TURKEY POINT PLANT UNIT NO. 3

Amendment No. 58
License No. DPR-31

TURKEY POINT PLANT UNIT NO. 4

SAFETY EVALUATION BY THE OFFICE OF NUCLEAR REACTOR REGULATION
RELATED TO AMENDMENT NO. 58 TO FACILITY OPERATING LICENSE NO. DPR-31
AND AMENDMENT NO. 51 TO FACILITY OPERATING LICENSE NO. DPR-41
FLORIDA POWER AND LIGHT COMPANY
TURKEY POINT PLANT UNIT NOS. 3 AND 4
DOCKET NOS. 50-250 AND 50-251

Figure 3.2-3

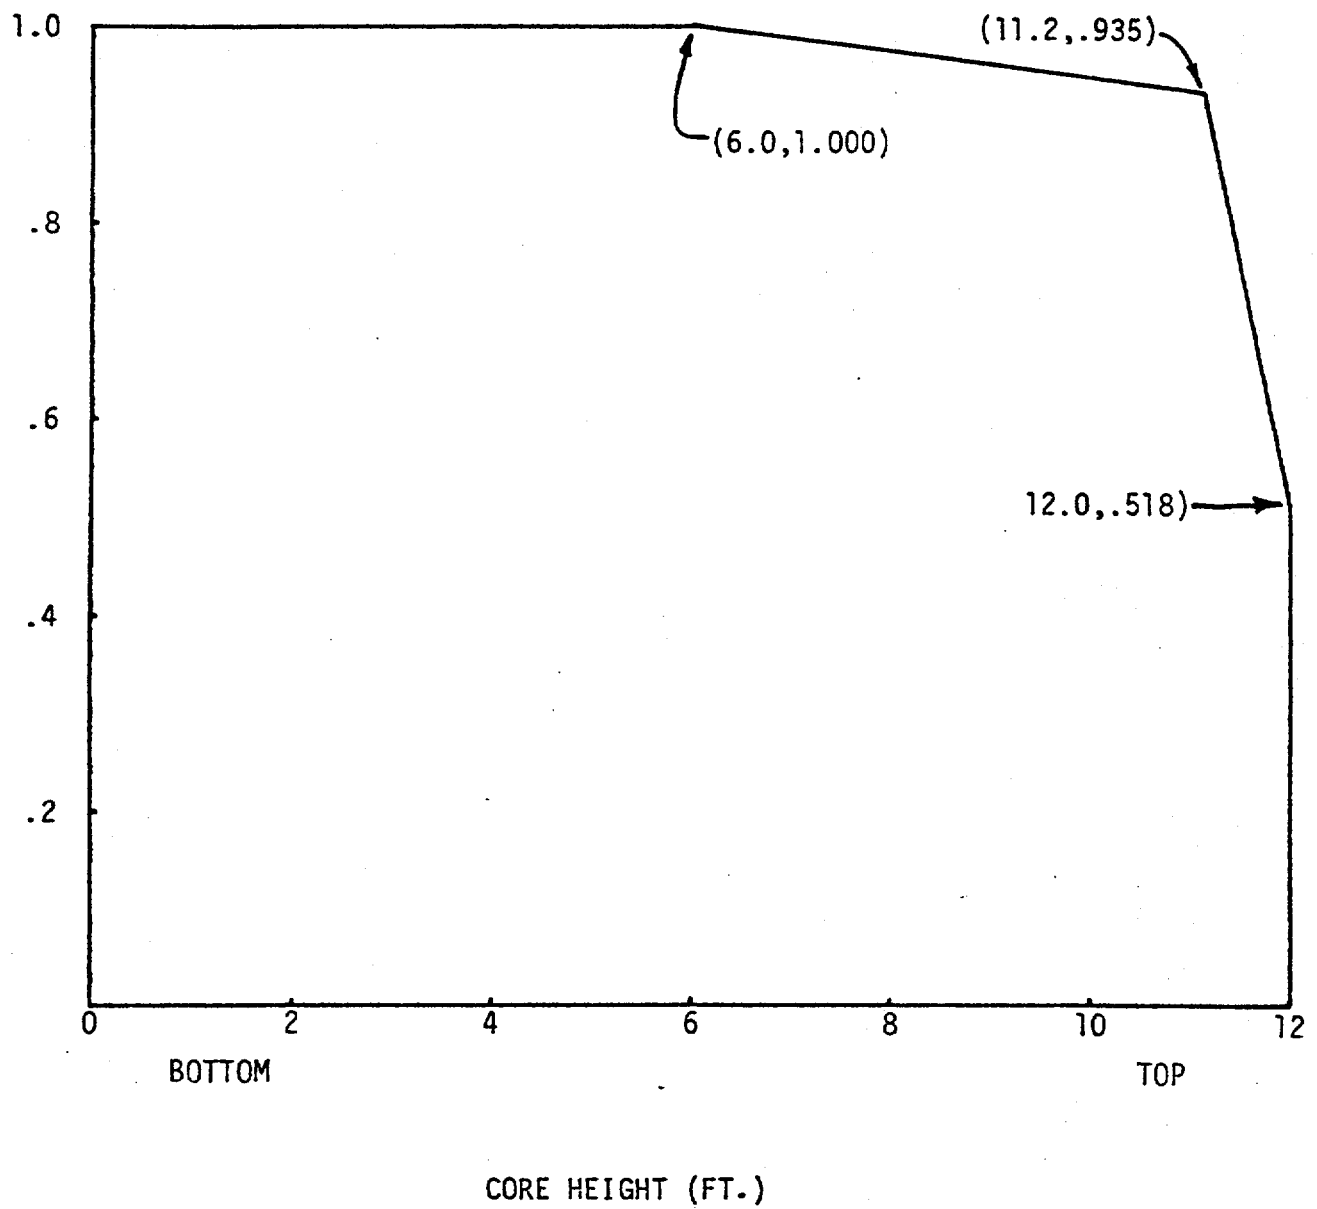
- (a) Specification of $F_0 = 1.93$ for plant operation with 25 percent of steam generator tubes plugged.
- (b) Change of the Hot Channel Factor Normalized Operating Envelope for a steam generator tube plugging level of as many as 25 percent (Figure 3.2-3).
- (c) Deletion of the specification for F_0 and the Hot Channel Factor Normalized Operating Envelope corresponding to a steam generator tube plugging level of 22 percent (Figure 3.2-3a).

With steam generator tube plugging $\leq 25\%$, the hot channel factors (defined in the basis) must meet the following limits at all times except during low power physics tests:

$$F_q(Z) \leq (1.93/P) \times K(Z), \text{ for } P > .5$$

$$F_q(Z) \leq (3.86) \times K(Z), \text{ for } P \leq .5$$

$$F_H^N \leq 1.55 [1 + 0.2 (1 - P)]$$

Where P is the fraction of rated power at which the core is operating; K(Z) is the function given in Figure 3.2-3; Z is the core height location of F_q .
